Assessment report to Sydney Central City Planning Panel

Panel reference: PPSSCC-258

DA number	SPP-21-00006	Date of lodgement	10 June 2021
Applicant	Landcom		
Owner	Sydney Metro		
Proposed development	Staged subdivision – stage 1 being 4 residue lots and public roads, stage 2 being 2 residue lots and public roads. Both with associated civil works including site remediation, tree removal, dam dewatering, importation of fill material and landscaping.		
Street address	Lot 10 DP27220, 93 Schofields Road, Rouse Hill Lots 2809 and 2817 DP1253963, Schofields Road, Rouse Hill Lots 2810-2813 DP1253963, Cudgegong Road and Schofields Road, Rouse Hill Part Lot 135 DP208203, 49 Terry Road, Rouse Hill Part Lot 5 DP 1190434, 95 Schofields Road, Rouse Hill		
Notification period	18 August to 17 September 2021 17 January 22 to 16 February 2022	Number of submissions	Nil

Figure 1 - extract from the DCP

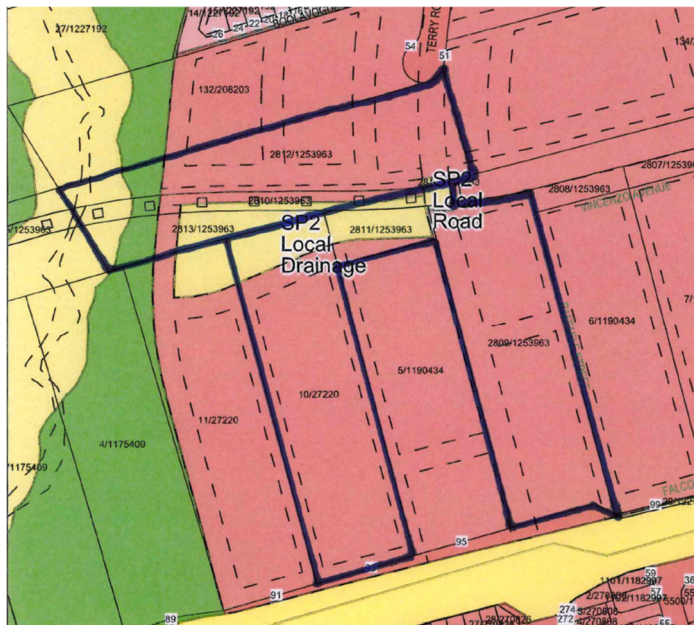
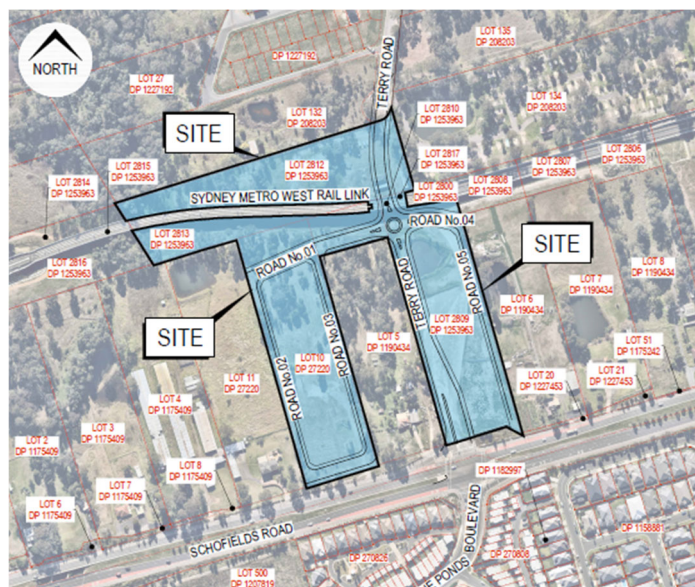
- 8.2.1 The proposed subdivision design will now include:
- deletion of 1 east-west indicative local road pattern within proposed Lot 1 and the site west of proposed Lot 1 (Lot 5 in DP 1190434), 1 of the roads to be relocated and extend east-west. This is due to the original local road pattern being too

close to the Schofields Road intersection. The proposed changes will reduce the risk of interference for traffic on Terry Road when approaching and leaving this intersection.

- the inclusion of a roundabout on the new east-west local road at the intersection along Terry Road with Schofields Road, which will provide flexible traffic movements between Terry Road and the sites in all directions.

The figure below shows before road pattern change (i.e those short east-west roads on Lots 5 and 2809).

8.2.2 Our Engineer and Traffic teams have reviewed the proposed changes and have raised no objections to these road pattern changes as it will result in safer traffic circulation.
